Review of Kerbs and Public Realm Design in Relation to Vehicle and
Pedestrian Access Requirements

Issued — 24 May 2024

OUR TOWN HALL

Mount Street Summary

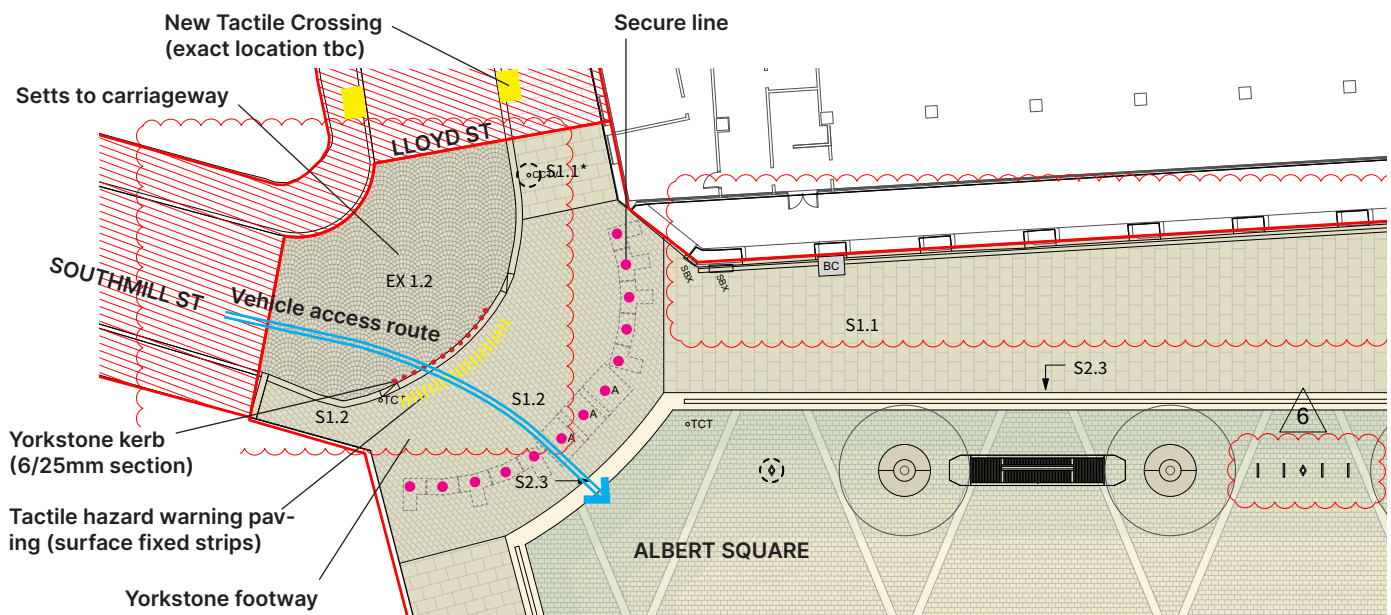
The kerb between the carriageway and footway will be black limestone, providing a visual and textural contrast to both footway and carriageway materials. The majority of works to this area have been completed and a 25mm kerb upstand has been installed adjacent to the loading and parking bays (see diagram below). This is in line with current government guidance (*Guidance on the Use of Tactile Paving Surfaces, Department for Transport, December 2021*).

- As this area is behind the vehicle secure line it is not a highway and is therefore of lower risk as vehicle speeds will be slower and controlled as vehicles are within a managed environment.
- It is recommended that where not already installed, kerbs are to have a 6mm upstand as Jane Simpson has identified that despite being in line with government guidance, a concern has been raised over the 25mm kerb upstand as a potential tipping hazard for wheelchair users.

- In line with Jane Simpson's comments, a 6mm kerb upstand will be installed to the remaining section of Mount Street and interface with Albert Square (radius kerbs).
- In addition to this, as agreed at a meeting between the LPA (Tony Mitchell and Lorraine Ward) and the OTH Project Team on 12.07.23, the kerbs to the corner of Central Street (desire line from Library Walk) have now been modified by a stone mason to create a dropped kerb and clear crossing point at this location.

Southmill Street Summary

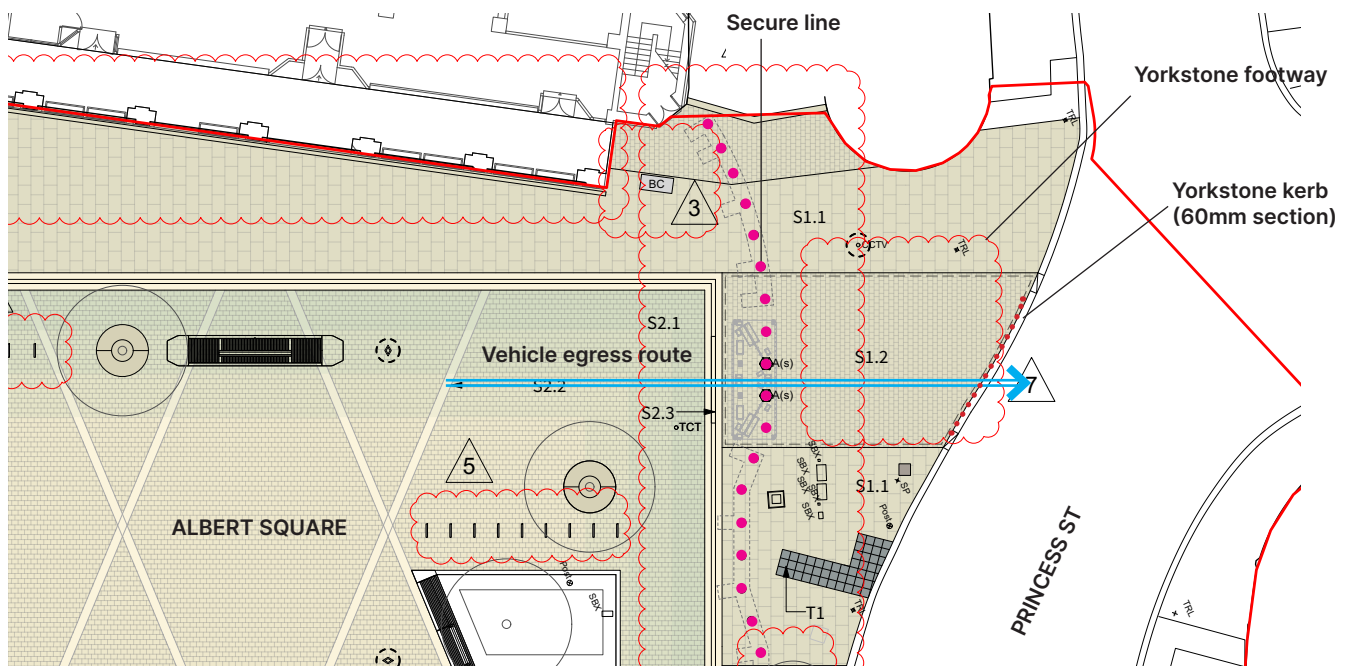
- Jane has advised that in locations where there is a requirement for vehicle access/egress, either a 60mm kerb upstand should be used, or alternatively a 6mm upstand alongside tactile blister paving (800mm width along extent of dropped kerb section).
- A 25mm kerb upstand has been highlighted as a potential tipping hazard for wheelchair users.
- The extent of the dropped kerb / flush access should be no longer than is required.

- It is acknowledged that the agreed solution should be one that is made with the advice and involvement of key parties from the Access Community.
- The section of dropped kerb / flush access is based upon vehicle tracking and does not extend further than is required.

- A 60mm kerb is not deemed to be appropriate at locations where vehicle access is required, especially due to the heavy loading requirement and the need for vehicles to 'bump up' over the kerb upstand.

- Two options are being considered to this area (subject to further development by the project team):
 - Option 1: Install the carriageway surface to provide a 25mm kerb upstand kerb to the area where vehicle access is required, this is in line with current government guidance for vehicle crossing points over kerbs (*Guidance on the Use of Tactile Paving Surfaces, Department for Transport, December 2021*).

- Option 2: Install the carriageway surface to provide a 6mm upstand kerb is proposed to the area where vehicle access is required. In addition, tactile hazard warning strips will be surface fixed to the footway adjacent to the 6mm edge as recommended by Jane Simpson.
